**CN Milton Logistics Hub – Project Changes
Report (Multiple Changes)**

File: 160901330

This report has been prepared to describe a series of proposed changes resulting from refinements made during the detailed design of the proposed terminal components. Section 2.0 provides a description of the proposed Project changes, including:

CN
MILTON LOGISTICS HUB - HALTON SUBDIVISION - PHASE 3
ADMINISTRATION BUILDING
PROFILES
WATER SERVICES

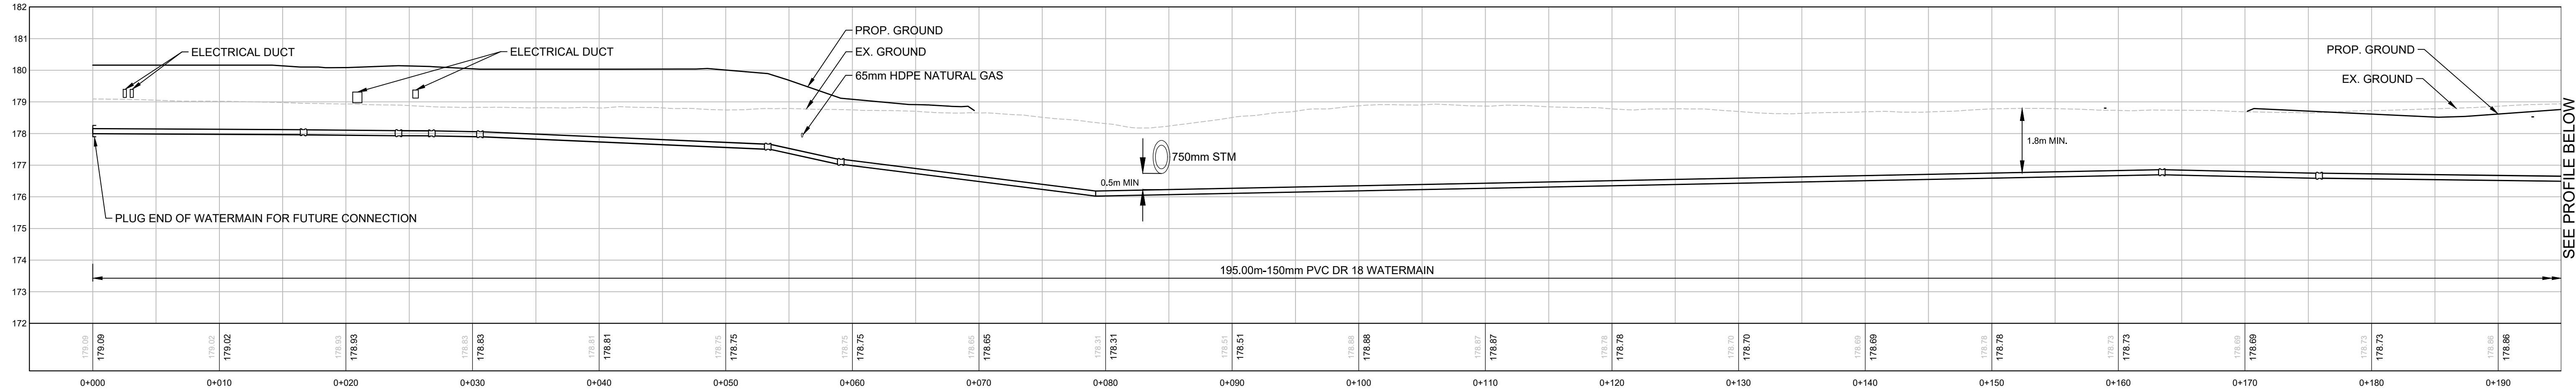
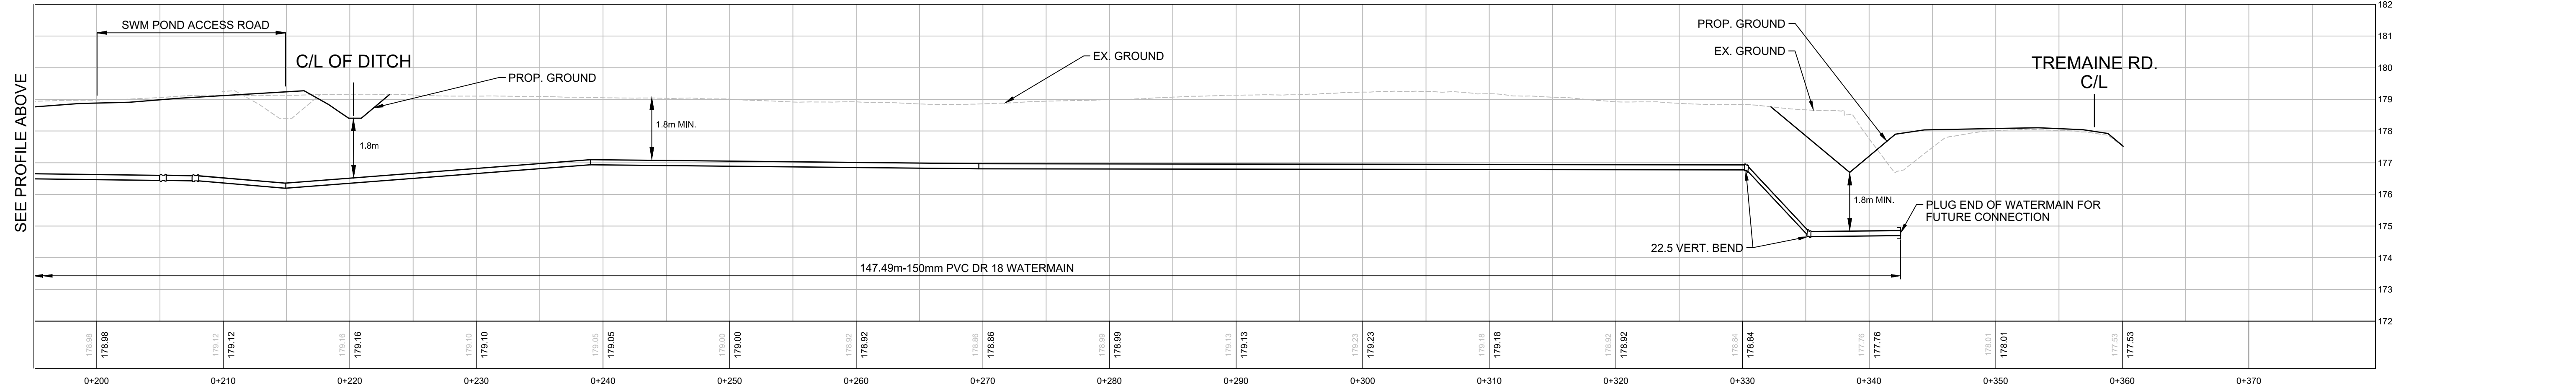
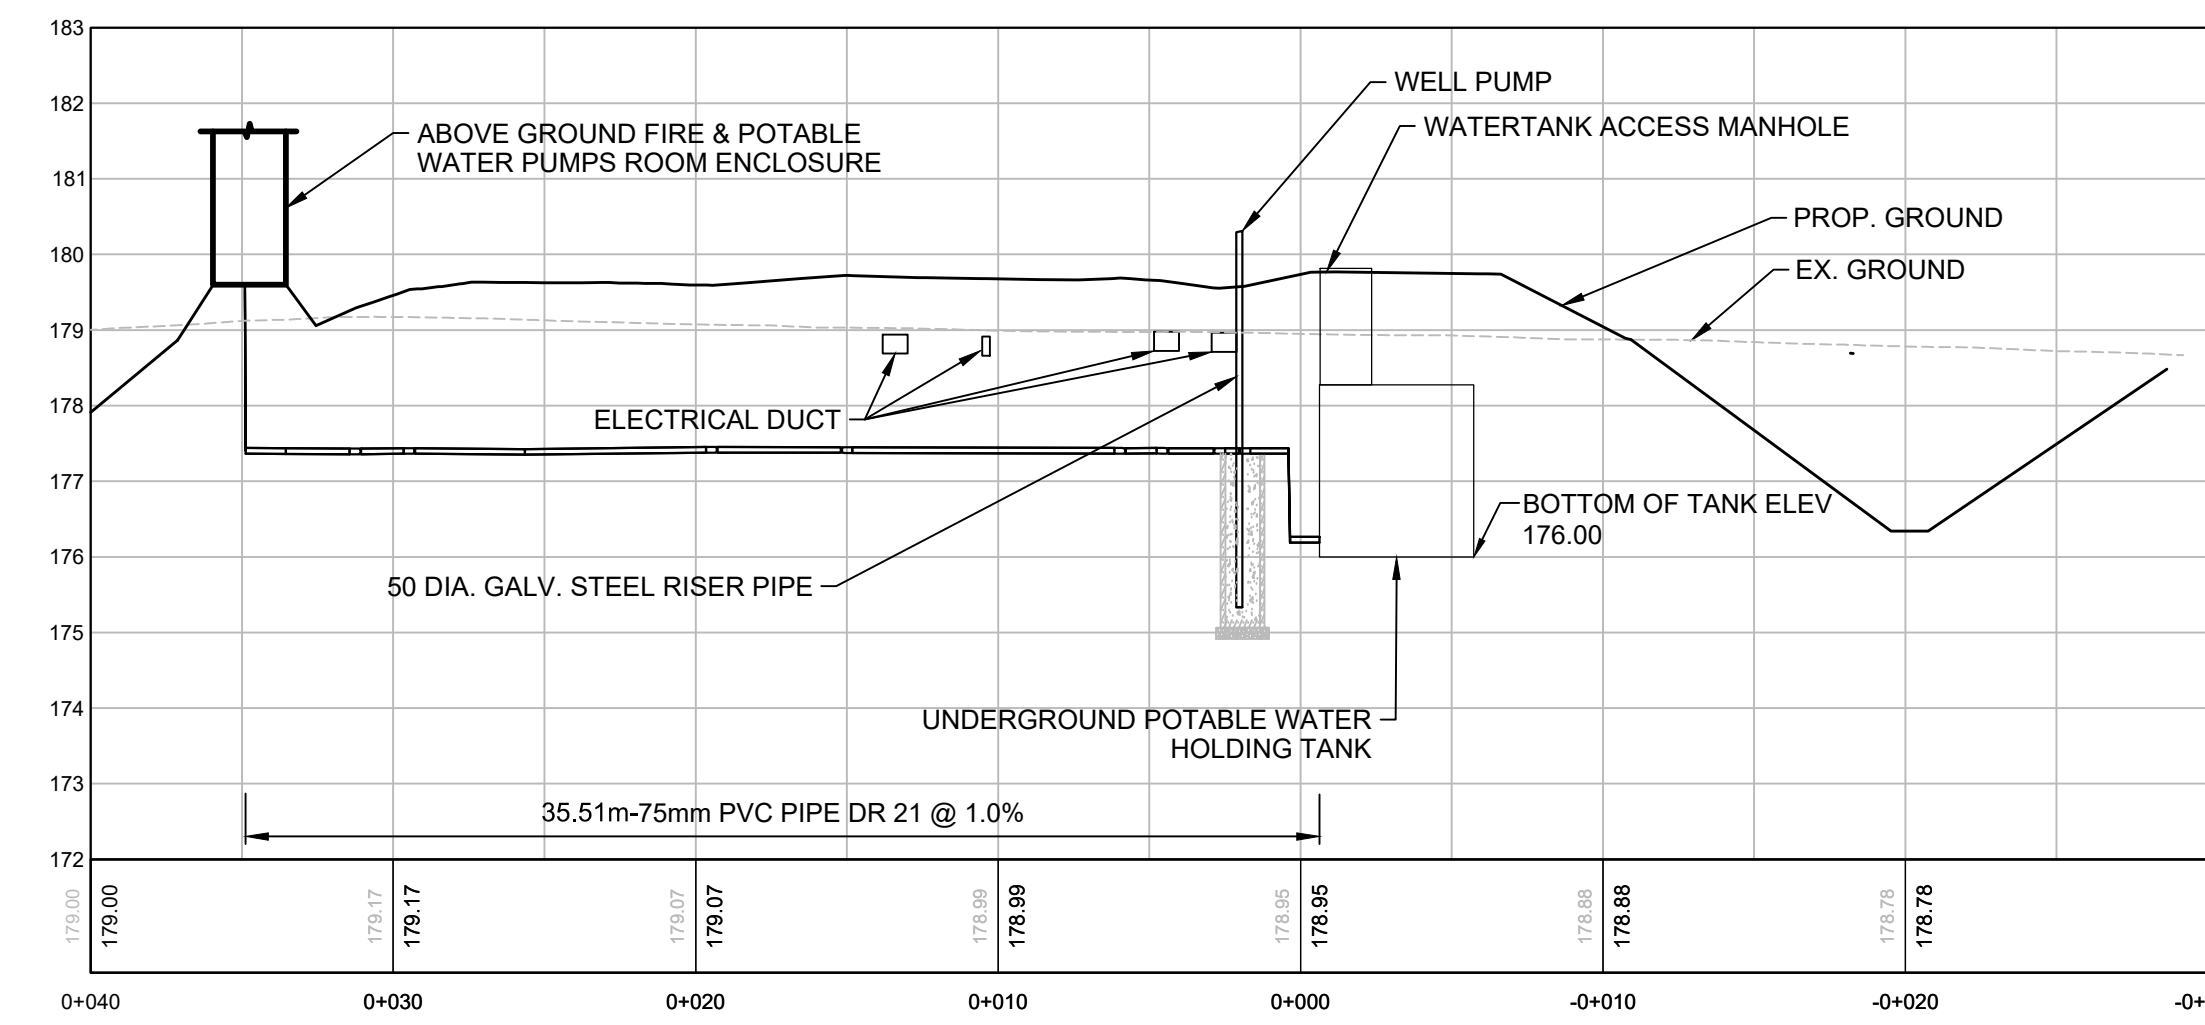
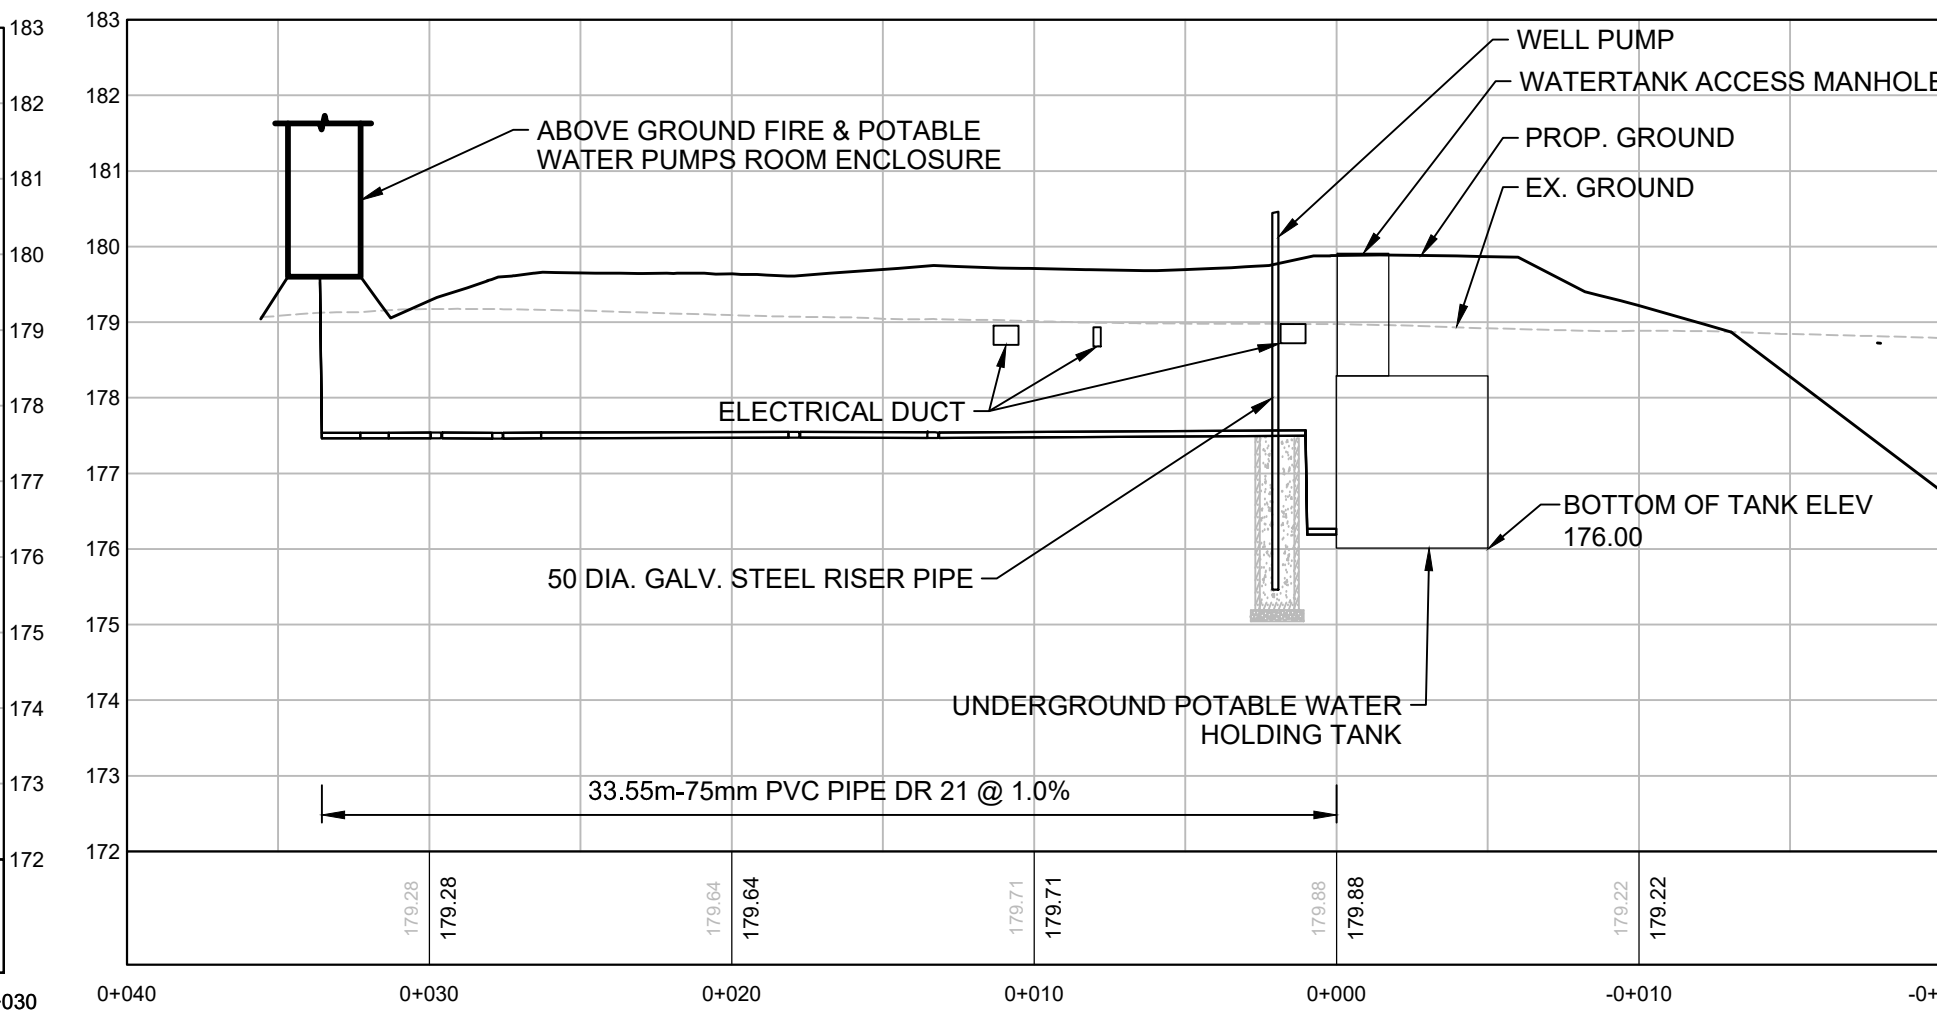
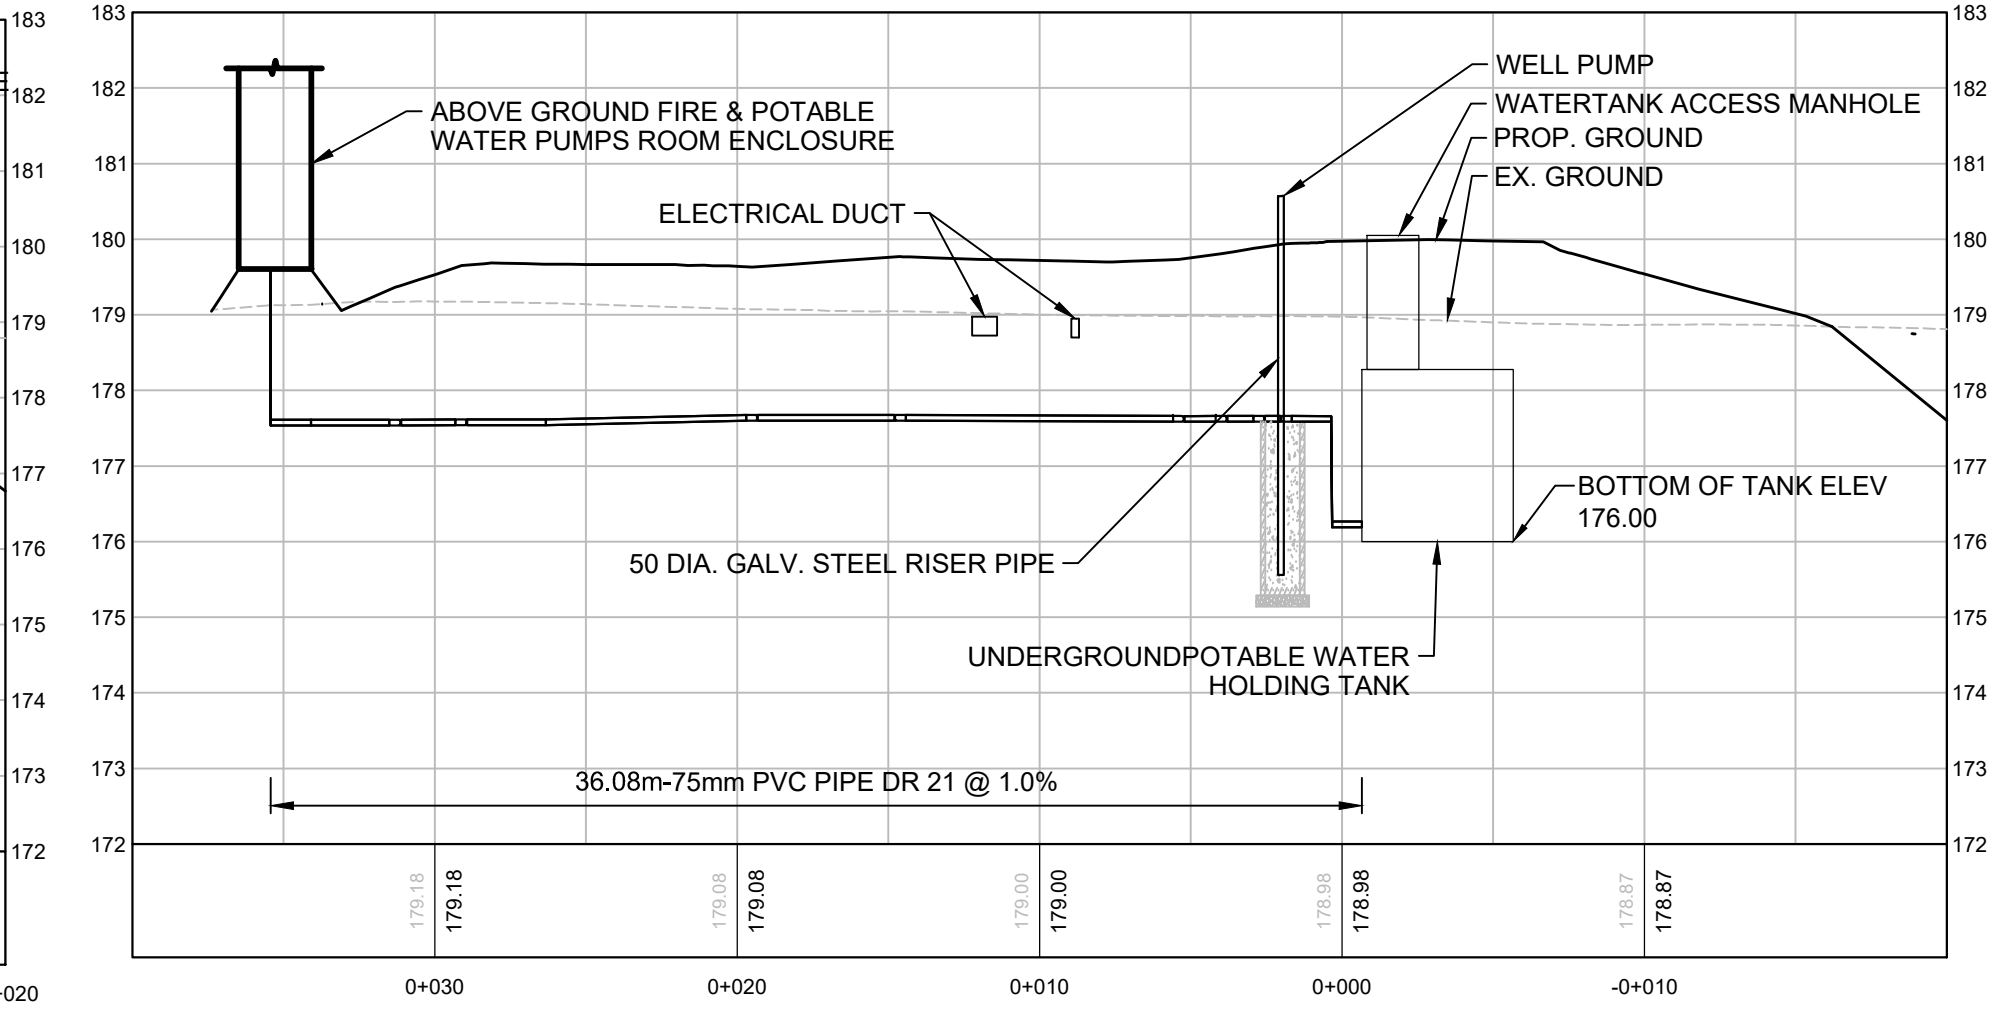
The updated design now includes three separate septic tanks with a combined storage capacity of approximately 15,000 gal to manage sewage and wastewater from the administration building and maintenance garage. The locations and details of these tanks are illustrated on the engineering drawings in Appendix B. These tanks would be constructed of precast concrete and installed below grade. Collected waste would continue to be pumped out and disposed of at a licensed disposal facility. The septic tanks would be maintained in accordance with the manufacturer's specifications.

The increase in total sewage storage capacity is intended to reduce the frequency of waste hauling. The use of multiple smaller sizes, rather than a single tank, will facilitate maintenance and regular clean-outs, reduce the potential for system failure, and avoid reliance on one tank for all sanitary sewage servicing requirements. No changes to the overall sanitary servicing strategy or method of waste disposal are proposed.
